DESIGN 	DRAWN BY 	DART AEROSPACE LTD HAWKESBURY, ONTARIO, CANADA	
CHECKED 	APPROVED 	DRAWING NO. DSI 9241	REV. A SHEET 1 OF 1
DATE 02.10.29		TITLE NEW SPACER	SCALE NTS
A	02.10.29	NEW ISSUE

## **DART SERVICE INSTRUCTION**

TO AMEND ICA-D105-674 REV. Ø  
REF. FAA STC: SR00910SE

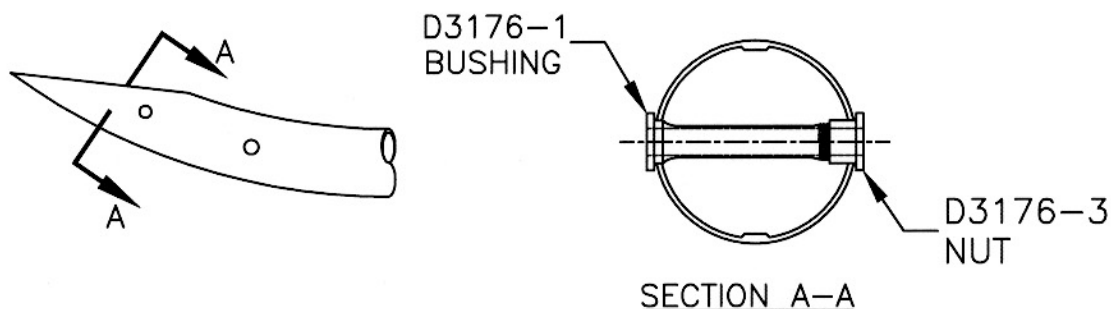
ON D105-674-011 CHANGE 002 OR LATER SKIDTUBES, D3176-1 BUSHING AND D3176-3 NUT HAVE BEEN INSTALLED AS SHOWN IN FIGURE 1 BELOW:

TO CONVERT D105-674-011 CHANGE 001 TO D105-674-011 CHANGE 002,

- 1) DRILL OUT EXISTING D2971 SPACER (Ø0.625)
- 2) OPEN TO Ø0.750 (2 PLACES)
- 3) TOUCH-UP ALODINE PER MIL-C-5541
- 4) INSTALL D3176-1/-3 PER SECTION A-A.
